DONCASTER BEVERLY DANBURY RECONSTRUCTION

CITY PROJECT NO. 14079
CONTRACT NO. 8709

ADDENDUM #1- 5/17/2024
REVISED THE FOLLOWING:
TITLE SHEET
SHEETS G12-G15
SHEETS PD1-PD2, PD5-PD6
SHEETS P1-P2, P5-P6
SHEET U2-U6
REMOVED THE FOLLOWING:
SHEETS G12 AND G16

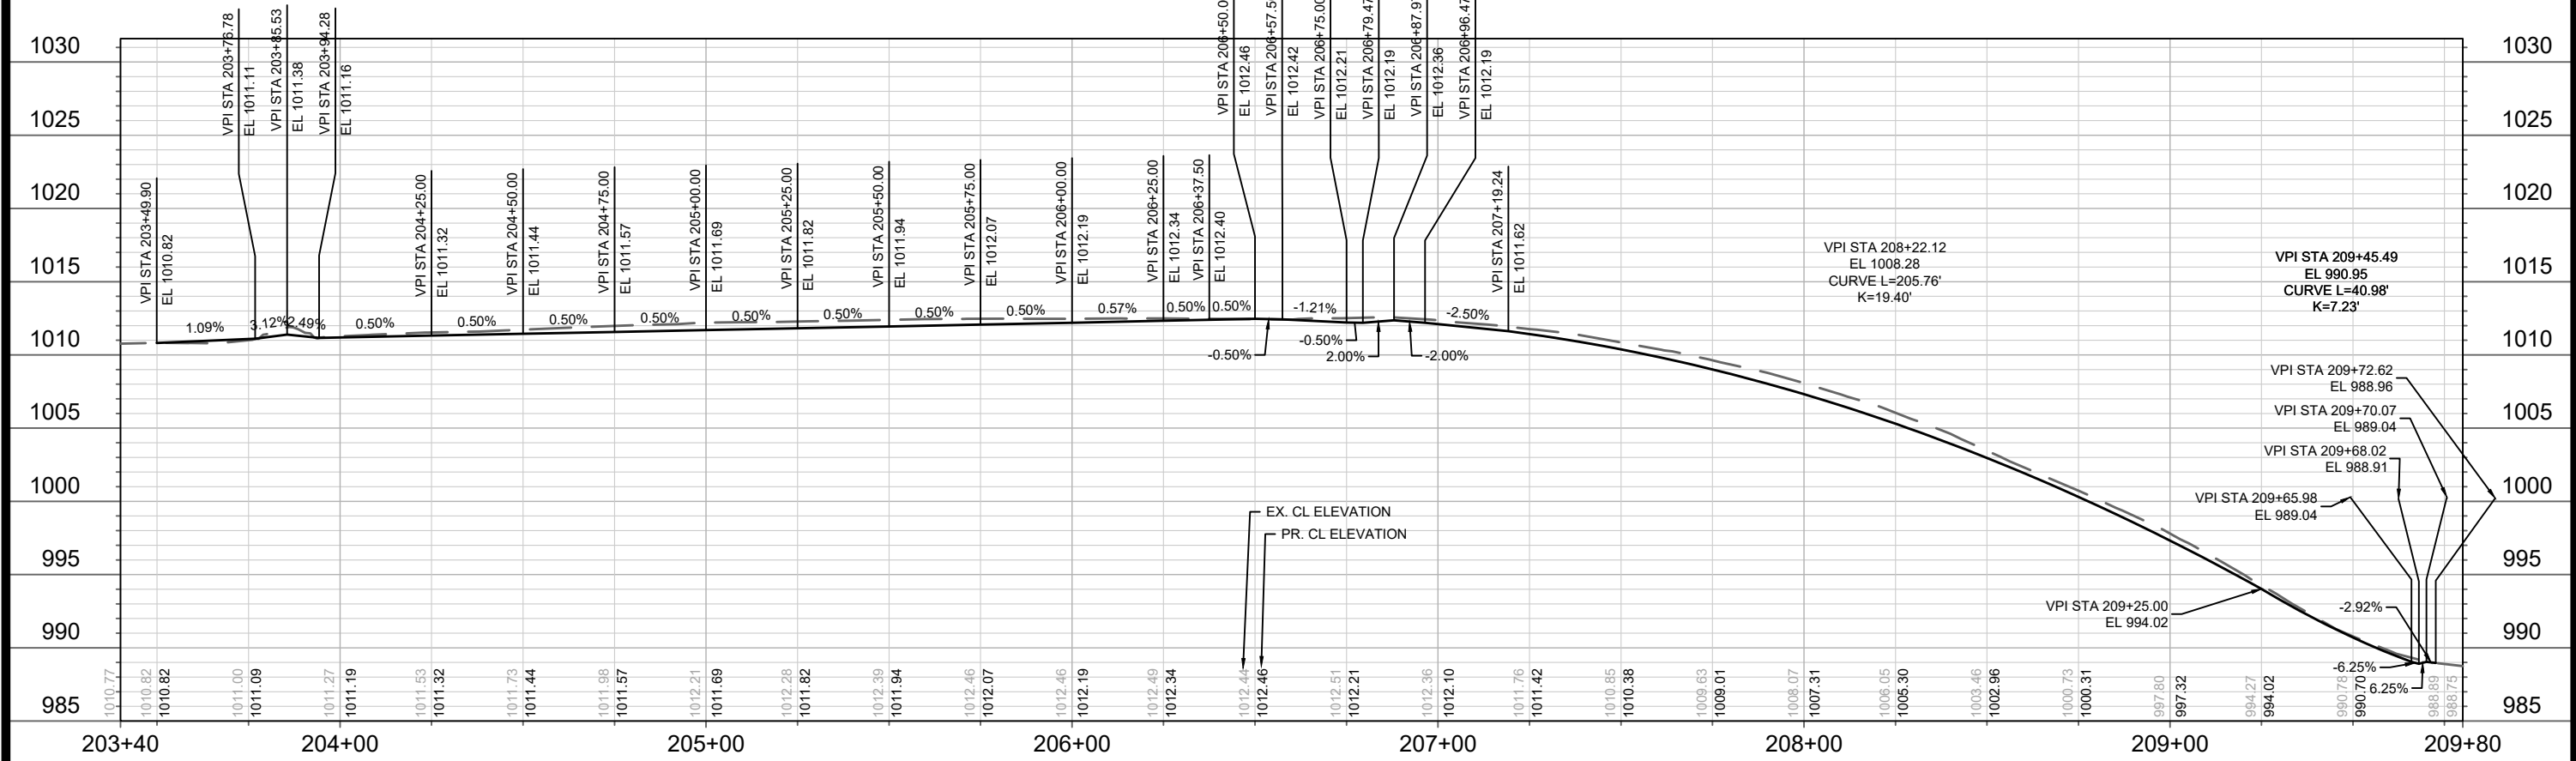
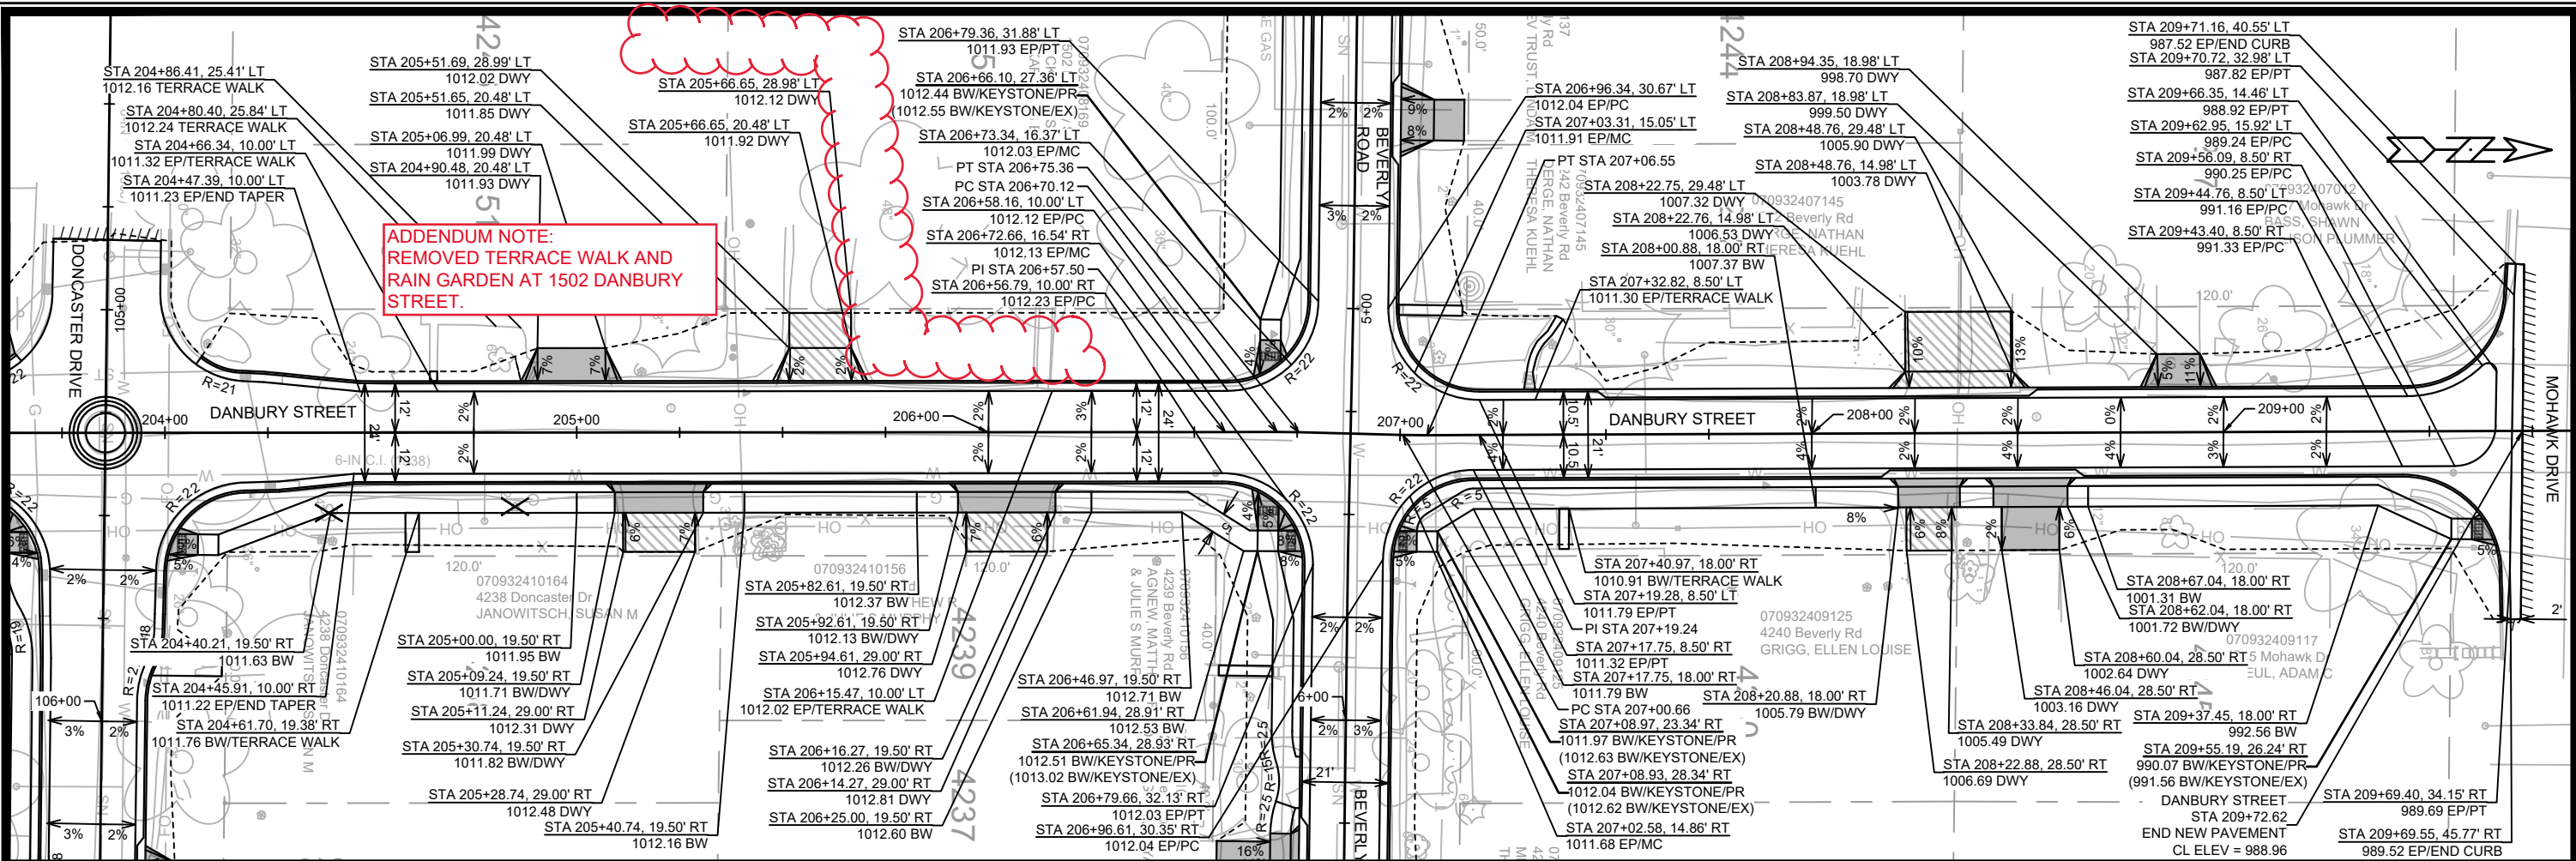
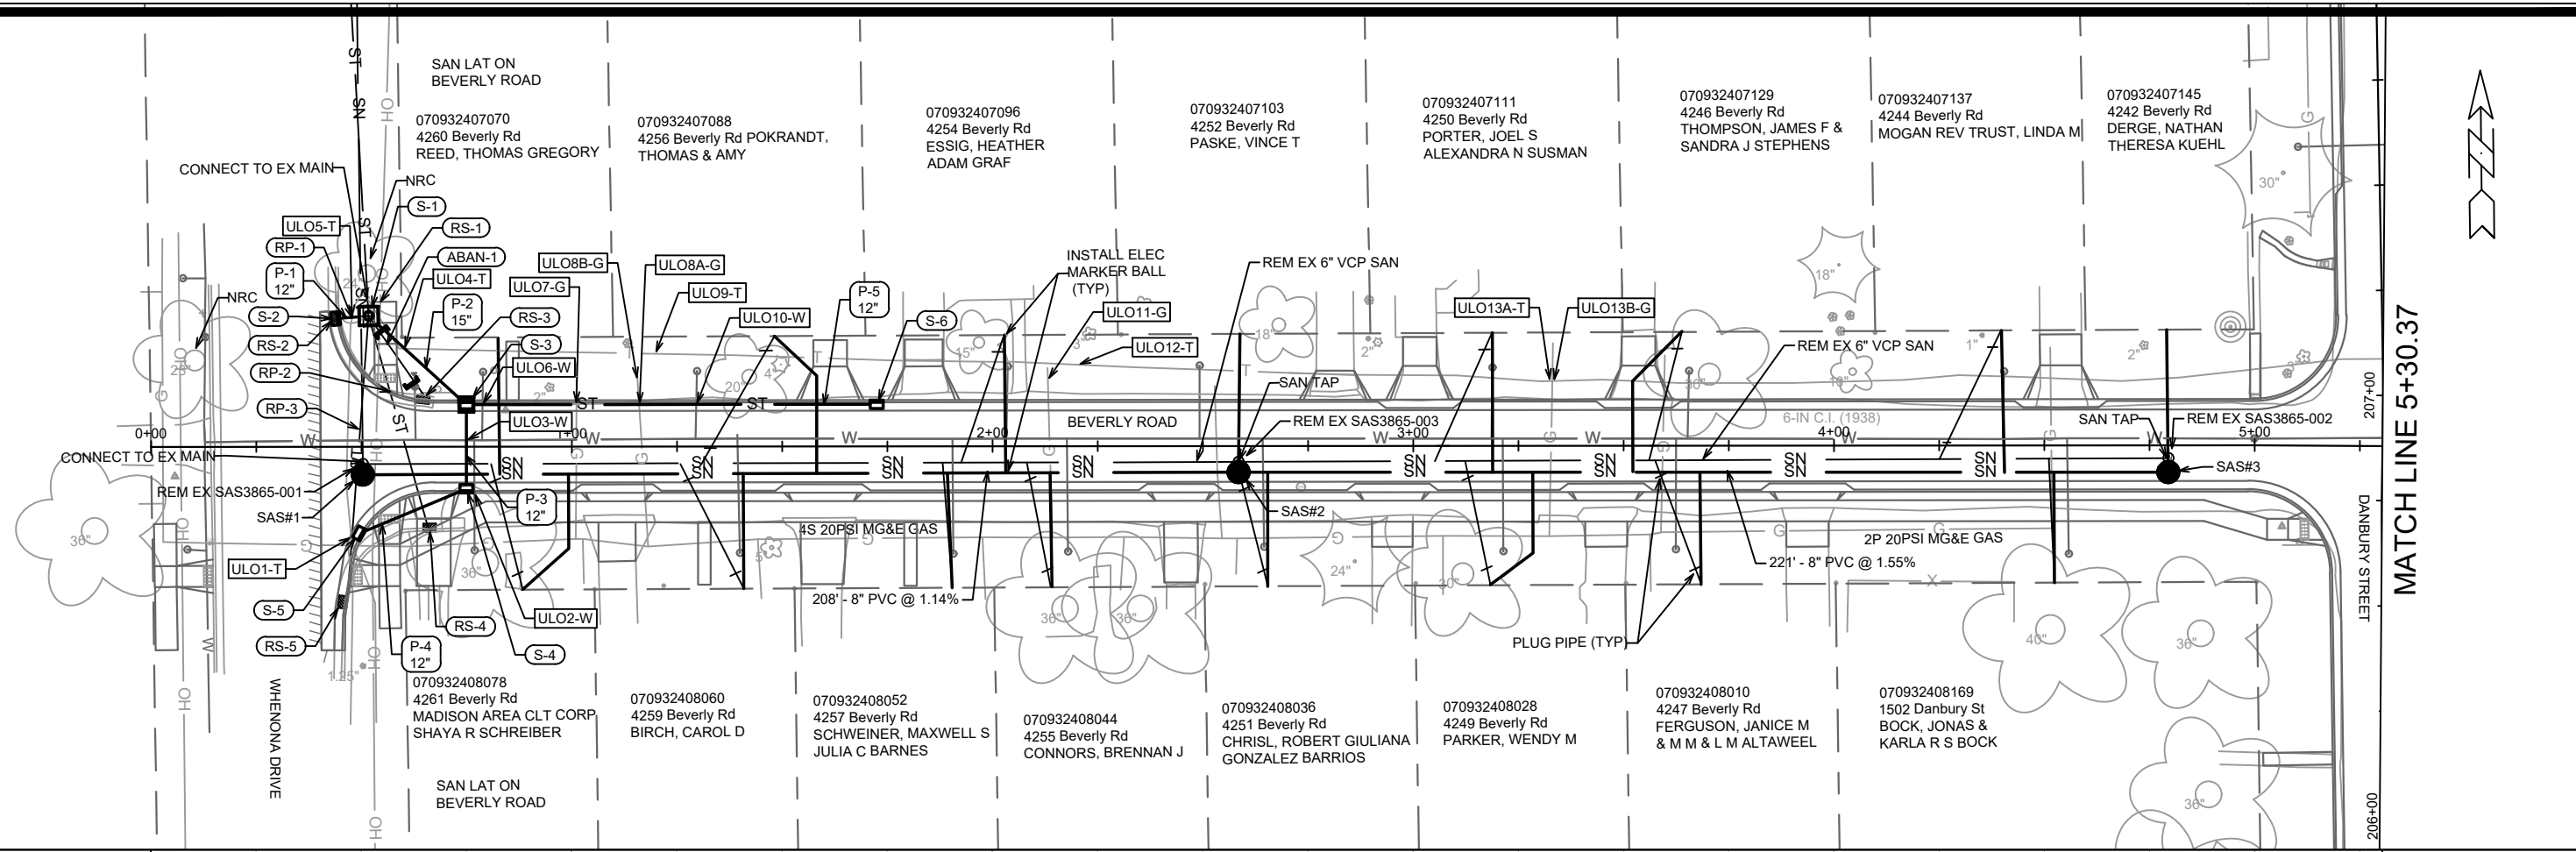
ADDENDUM NOTE:
REMOVED TERRACE WALK
AT 4201 DONCASTER DR

MARK	AD#1	REVISION	Date: 5/17/2024 8:10 AM	Scale: 1" = 40'
DATE	5/17/24	EKG	BY	U-2

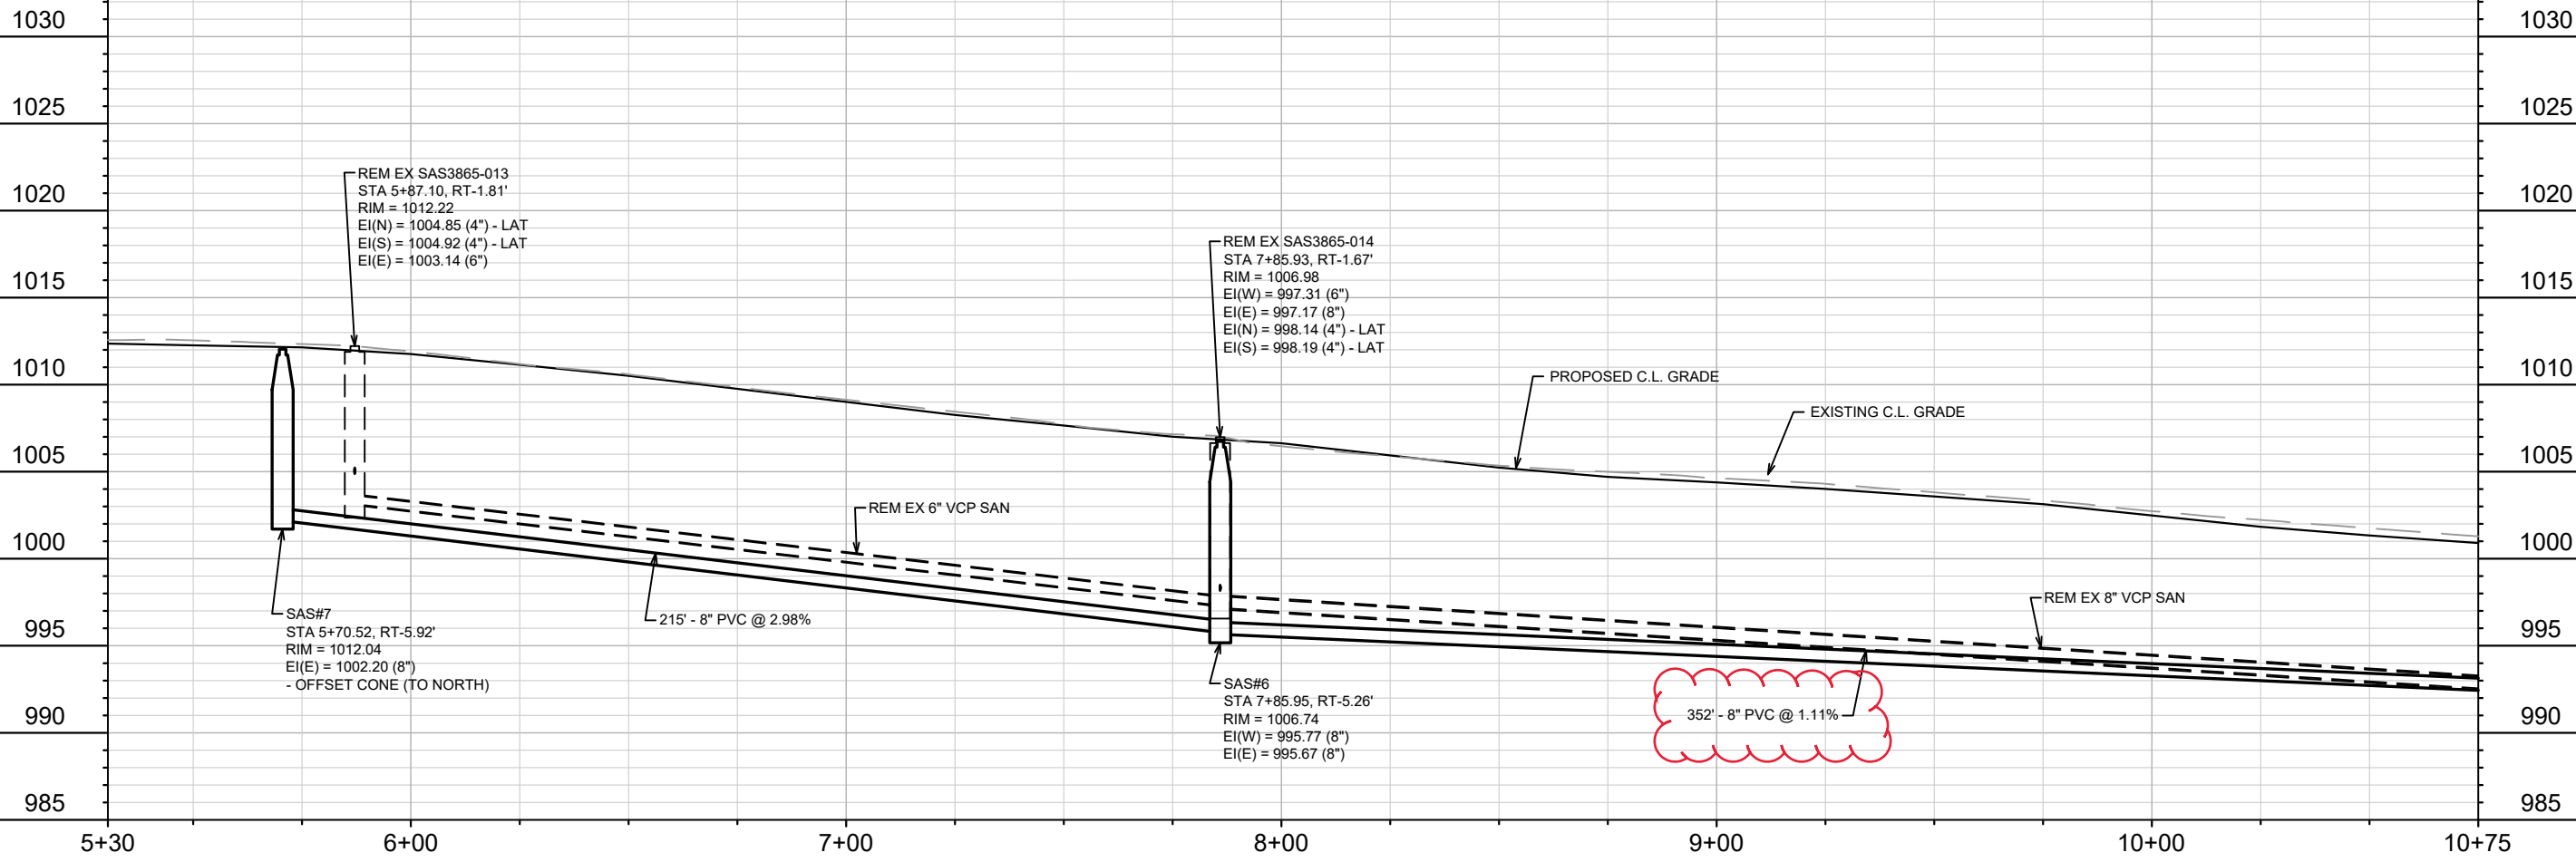
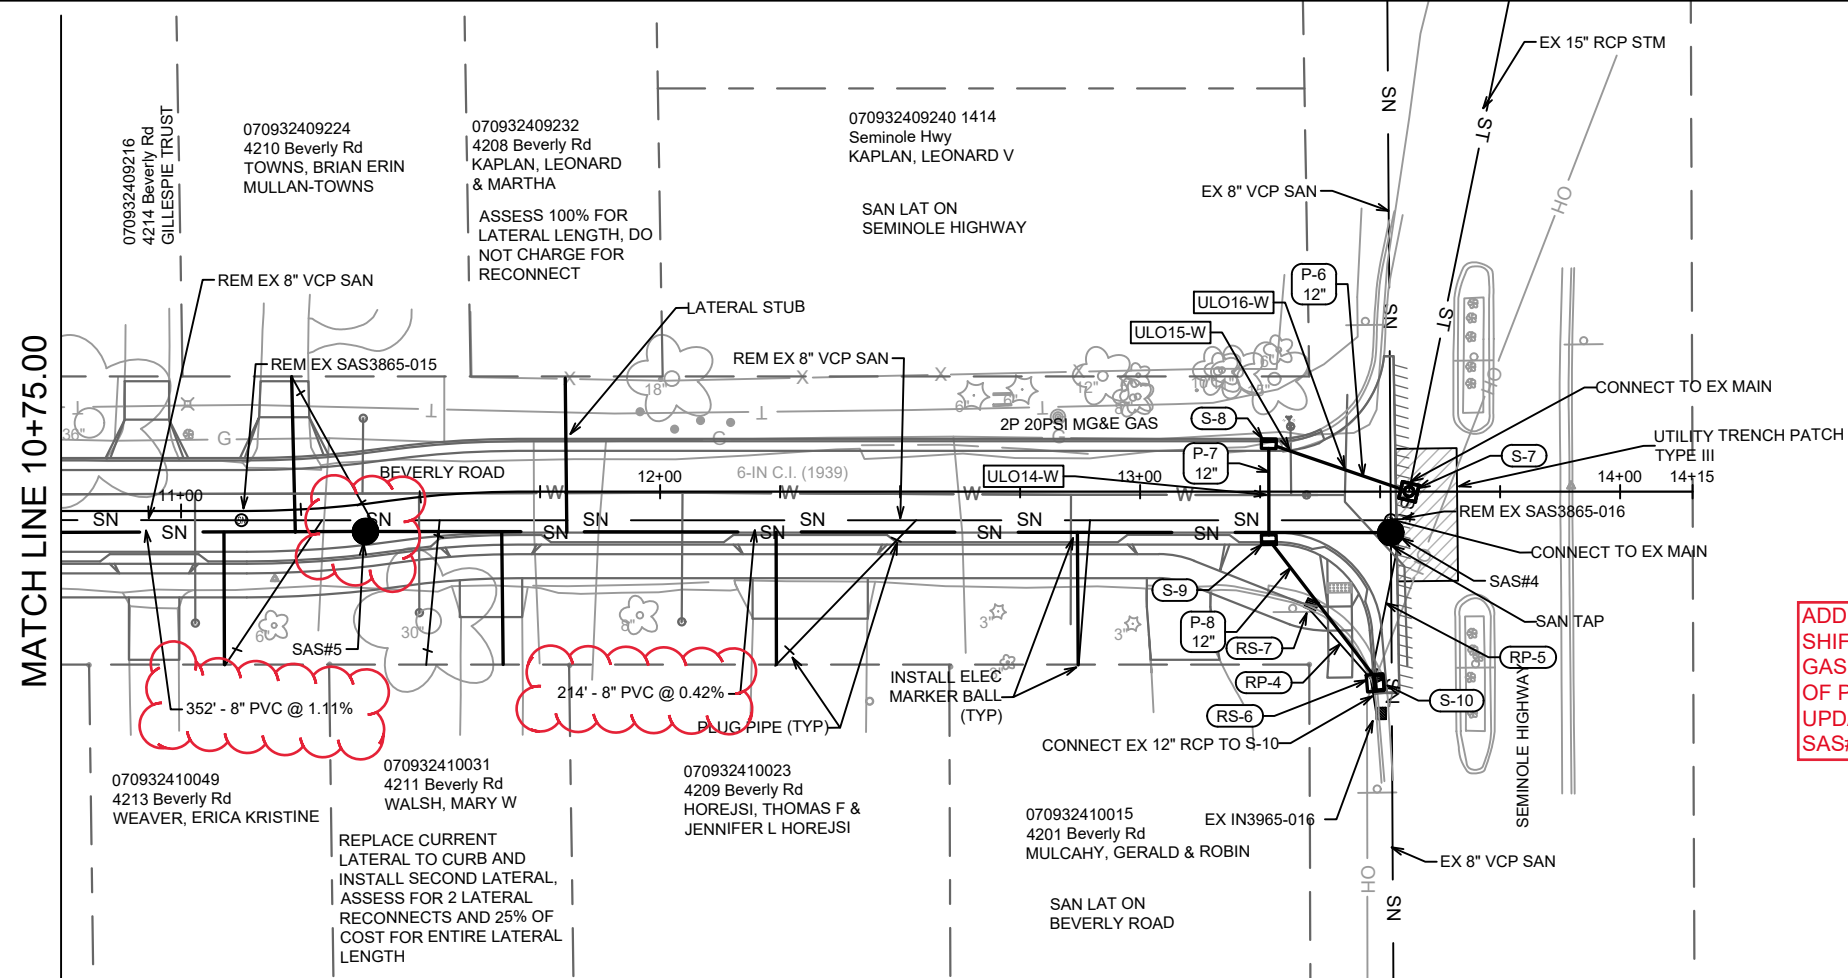
ADDENDUM NOTE:
 ADDED RETAINING WALL AT 4233 BEVERLY RD. UPDATED LENGTH OF PIPE FROM SAS#5 TO SAS#6.
